Tutti i modelli - All Models

953

Subject.: UFI oil filter, part. no. 191993

Fig. 1

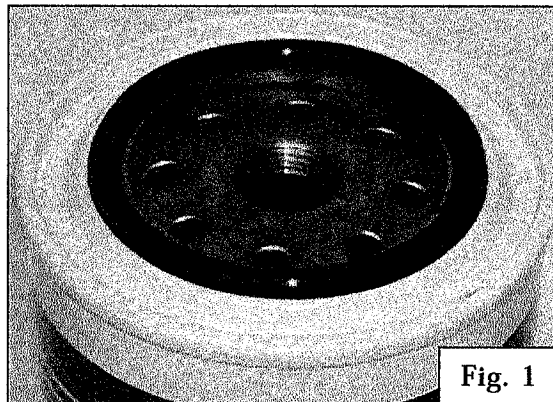
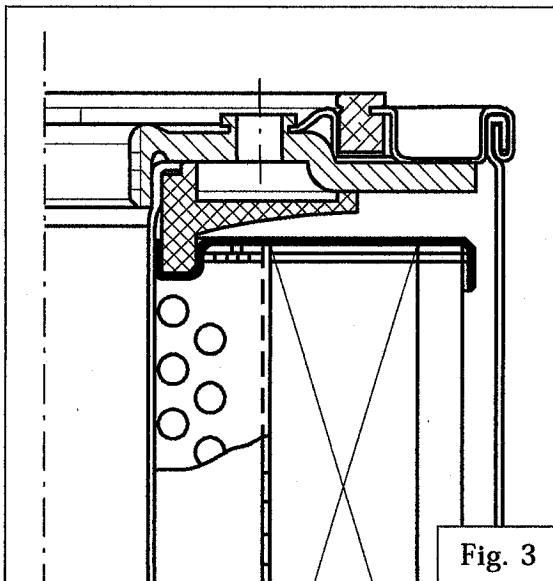
The oil filter, part no. 111782 (Fig. 1) can cause oil leaks from the round-shaped seal ring fitted on circulating cars.

This oil filter features a "welded" (not riveted) plate and was produced starting from 31st May 2000.

To prevent this potential problem, our supplier UFI has produced a new oil filter, part no. 191993 (Fig. 3), maintaining the manufacturing specifications of the riveted plate and fitting a new square-section seal, in the place of the round-shaped one.

Considering the potential problem, we have decided to recall all vehicles equipped with the oil filter part no. 111782, whose plate is welded and which can be easily identified through the manufacturing date - that can be either 31st May 2000 or a subsequent date - shown on the upper part of the filter itself. The old part must be replaced with the new oil filter, part no. 191993.

Fig. 2

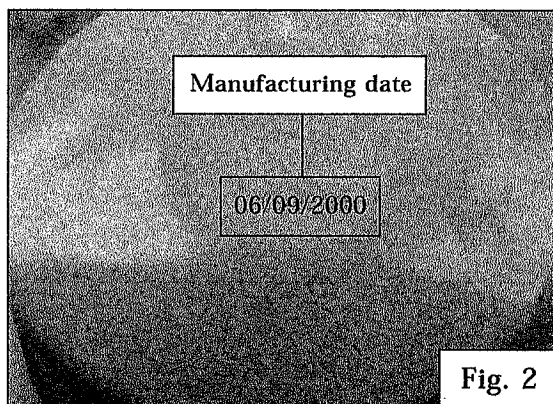
N.B.: the oil filter manufacturing date is indicated on the upper part of the filter itself (Fig. 2).
